FACT SHEET

KVA Power LLC proposes to construct and operate a 838 megawatt (MW) gas-fired combustion turbine facility (Northwest Regional Power Facility or NRPF) near the town of Creston, Washington. The project site is approximately 1,200 acres, of which less than 140 acres will be impacted. The footprint of the facilities permanently impacts 75 acres; 70 acres of agricultural lands and 5 acres of three-tip sagebrush/Idaho fescue habitat. The remaining 65 acres will be temporarily disturbed during construction of an underground gas pipeline, an underground water pipeline, and grading for the area used for the collection of stormwater runoff into the stormwater retention pond.

CORRECTIONS AND MODIFICATIONS TO THE DEIS

FIGURE 1-1
 Conceptual Site Layout

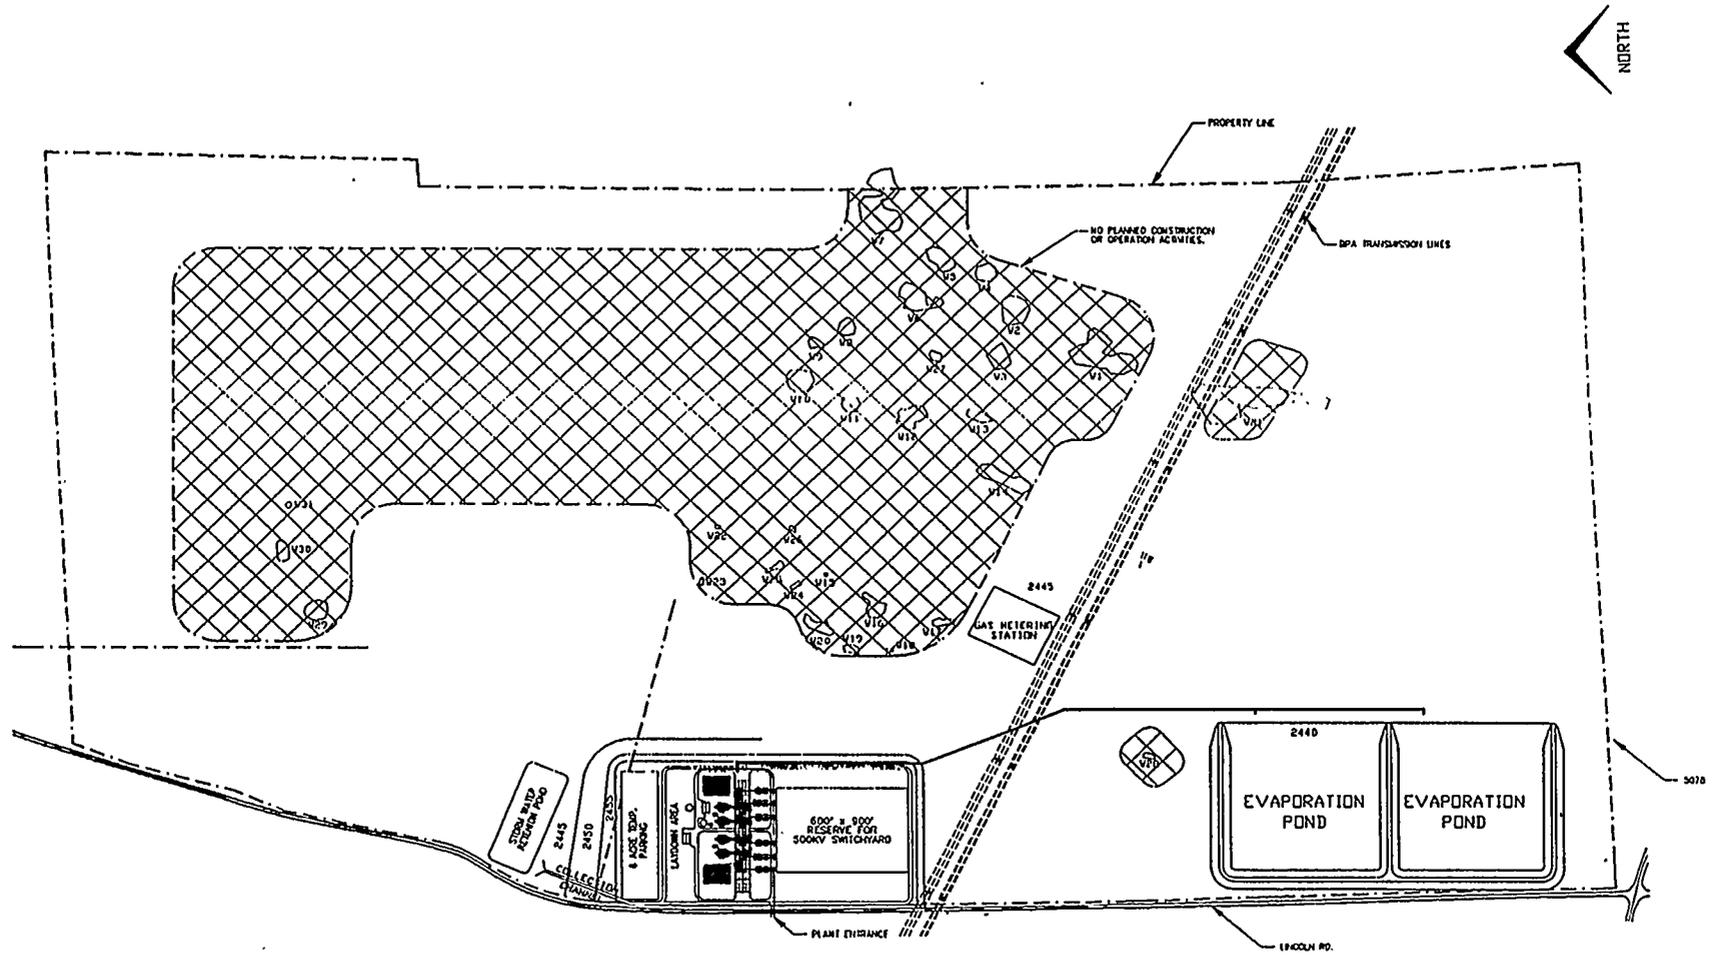
Page 1-5, Figure 1-1: See revised Figure 1-1.

Page 1-5, Figures 1.1 and Page 2-3, Figure 2.2: For clarification these need to be turned to match the other figures, i.e., Figure 2-5, 'North', and a scale need to be added.

Figure 1-1 should be replaced with a figure that conveys the most complete wetland and habitat data. Such a figure was produced by CSWE for submittal to EFSEC as part of the post-hearing material.

FIGURE 2-1
Site Location Map

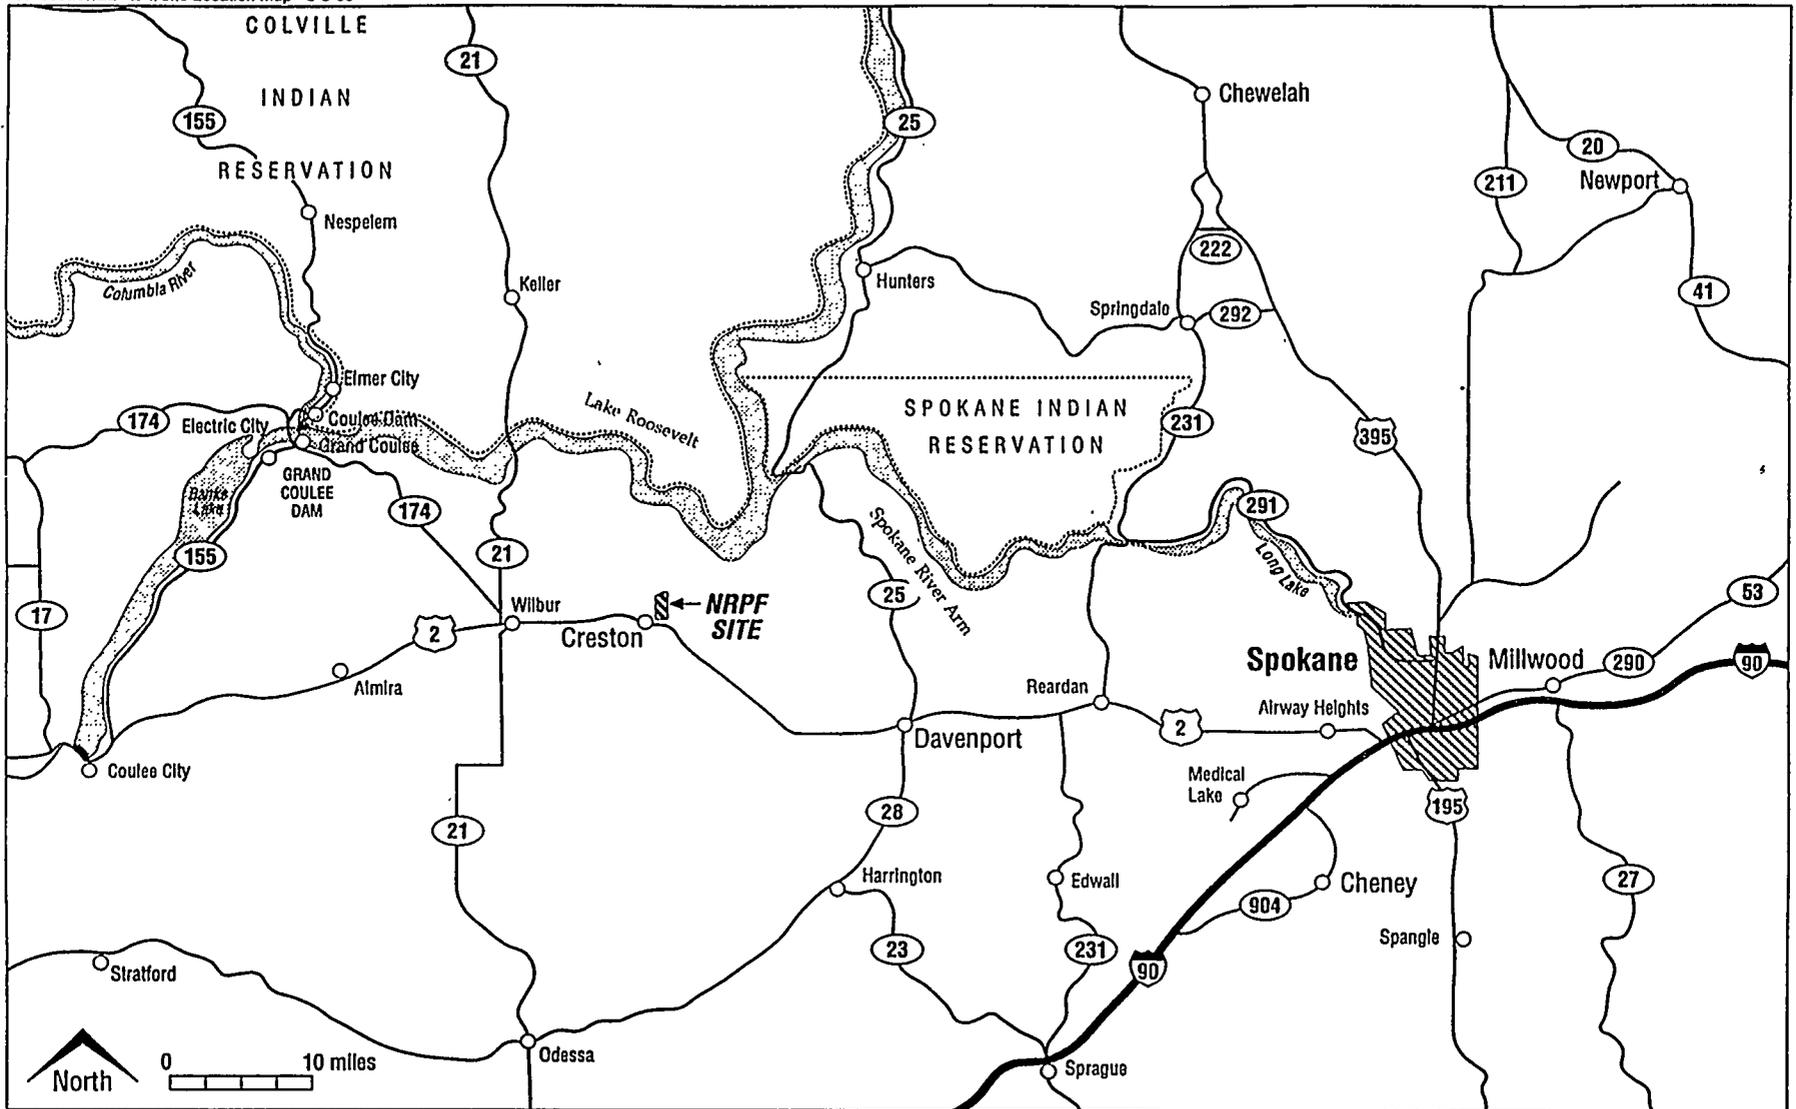
Page 2-3, Figure 2-1: See revised Figure 2-1.

Page 2-3, Figure 2-1, "Spokane River Falls Lake": This should read "Spokane River Arm" and "Franklin Roosevelt Lake" should read "Franklin D. Roosevelt Lake"; or, our preference is "Lake Roosevelt." You could also identify "Coulee Dam National Recreation Area."

- B-6 Comment noted. Changes made to text. Please refer to Chapter 2 (Corrections and Modifications to the DEIS) of this document.
- B-7 Comment noted. Suggested changes made to figure. Please refer to Chapter 2 (Corrections and Modifications to the DEIS) of this document. The location of the Coulee Dam National Recreation Area is shown on Figure 3-13, page 3-117.

FIGURE 2-2
Conceptual Site Layout

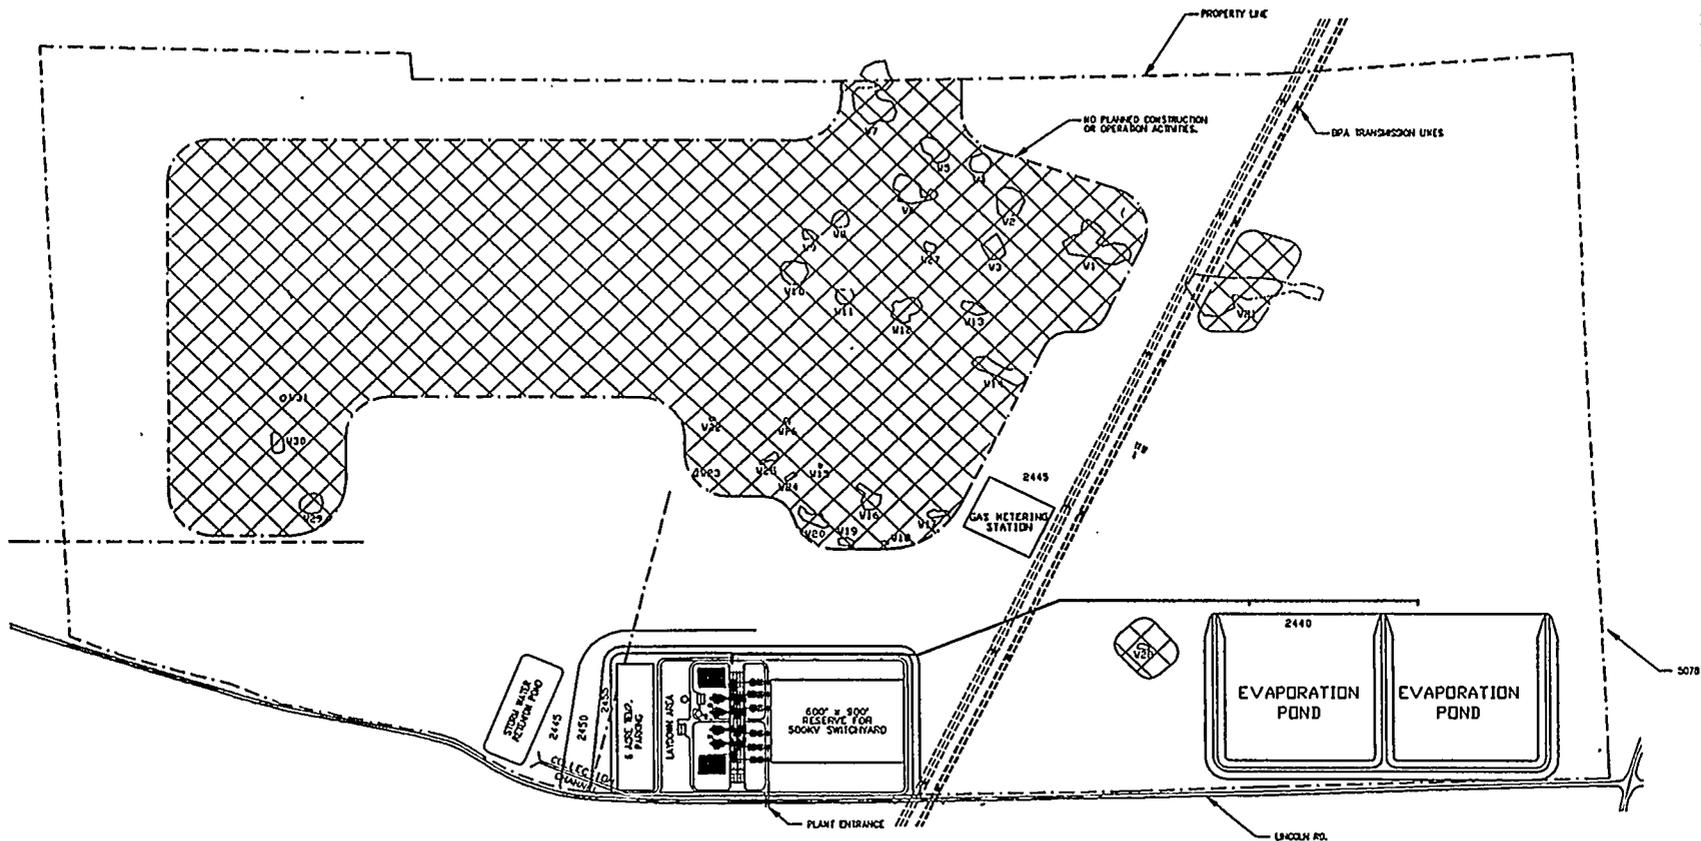
Page 2-5, Figure 2-2: See revised Figure 2-2.

Page 2-5, Figure 2-2:

Figure 2-2 should be replaced with a figure that conveys the most complete wetland and habitat data. Such a figure was produced by CSWE for submittal to EFSEC as part of the post-hearing material. 23

FIGURE 2-9
NRPF Transmission Route
Map 1: Location Map

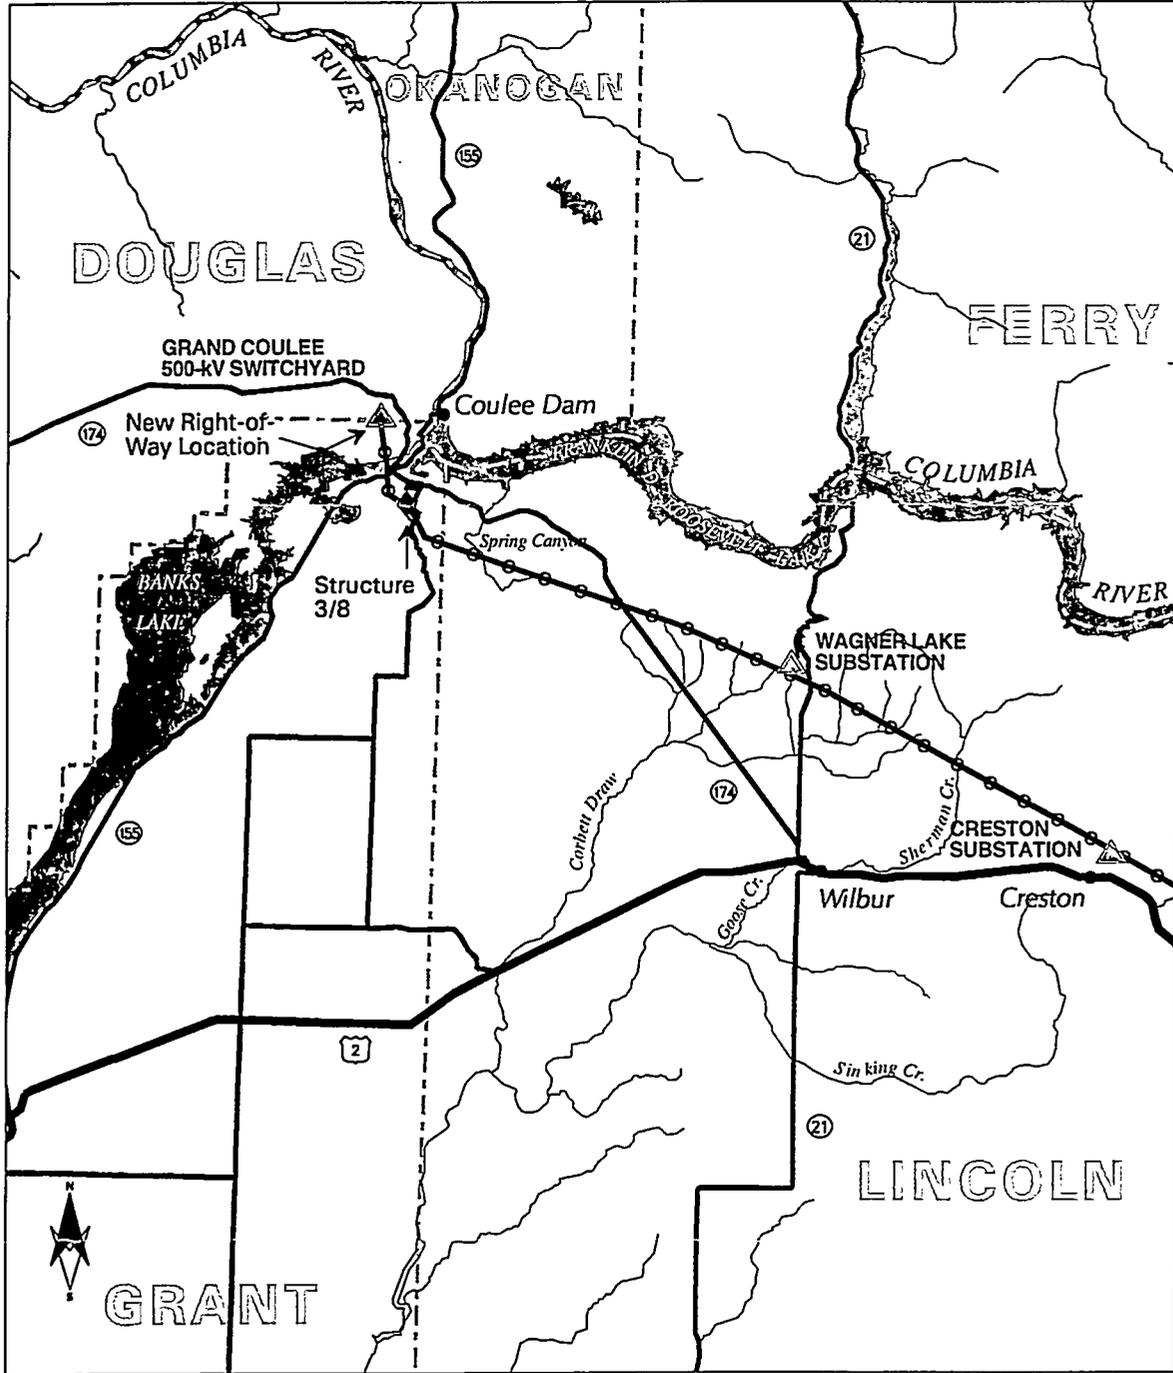
Page 2-37, Figure 2-9: See revised Figure 2-9.

FIGURE 3-9
NRPF Transmission Route
Map 2: Major Land Ownership or Designation

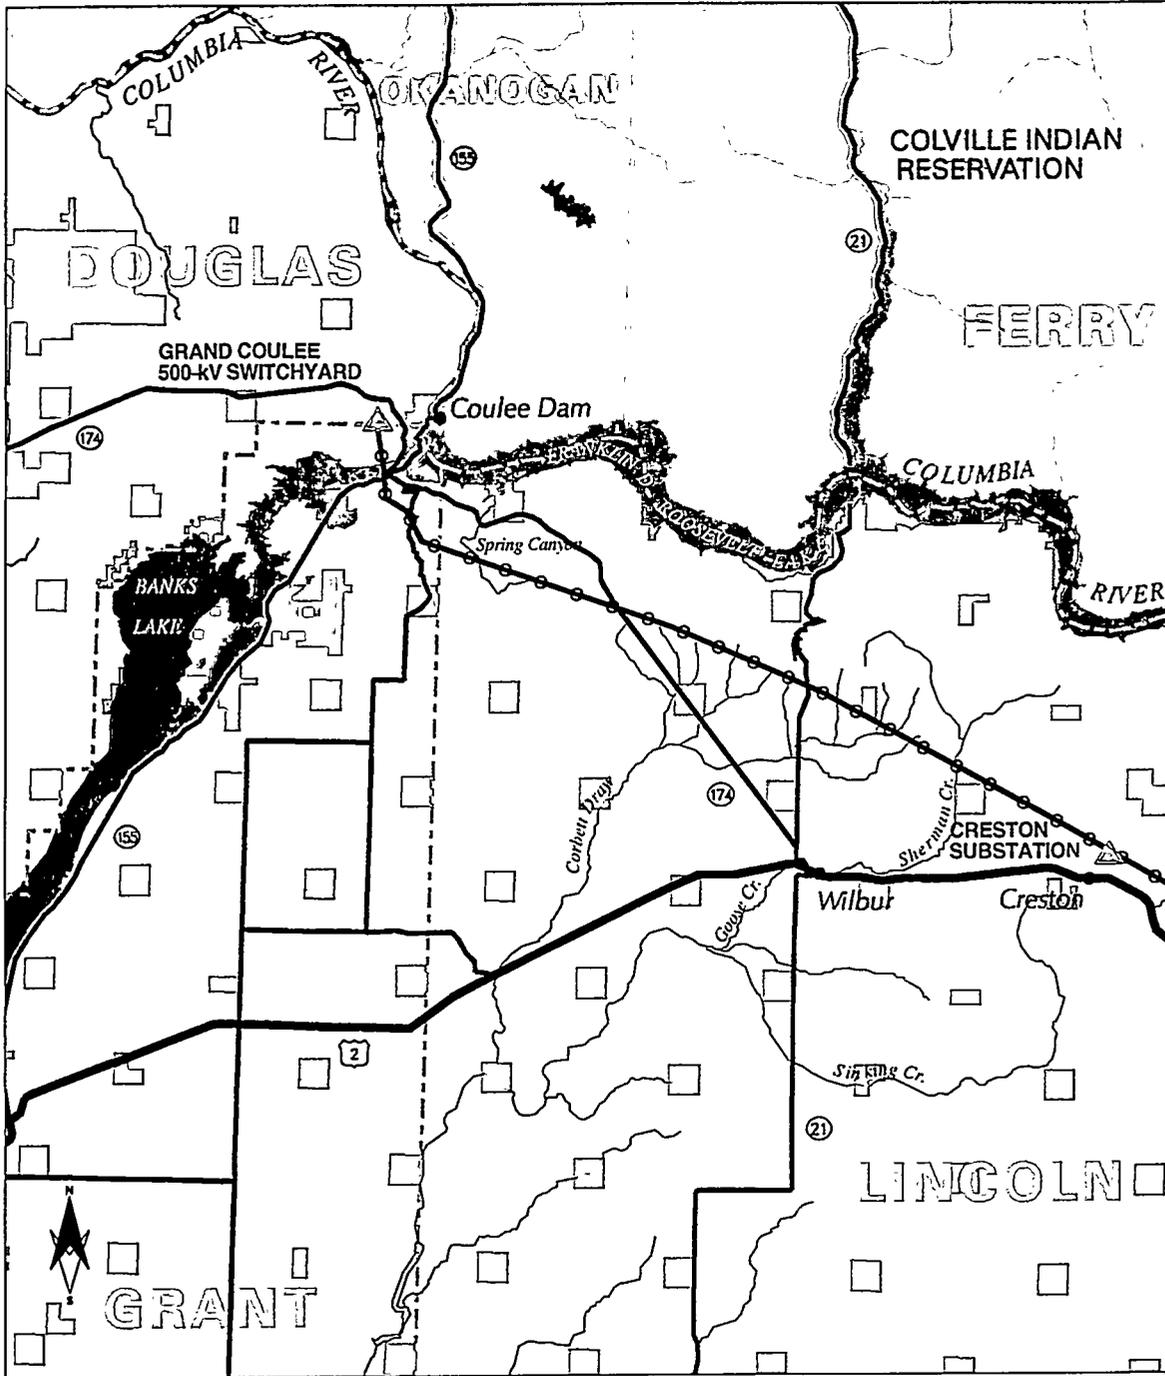
Page 3-97, Figure 3-9: See revised Figure 3-9.

- R-8 Comment noted. Figure 3-9 has been revised. Please refer to Chapter 2 (Corrections and Modifications to the DEIS) of this document.
- R-9 BPA not building the line to Bell Substation in Spokane has little implication for this project. There is no need to build a line to Bell Substation. The new plant needs to be integrated into the transmission system. Since the load centers that may be served by the plant are to the west and south, the power will not need to flow east toward Spokane. A line to Grand Coulee allows the power to flow in the direction of greatest need.
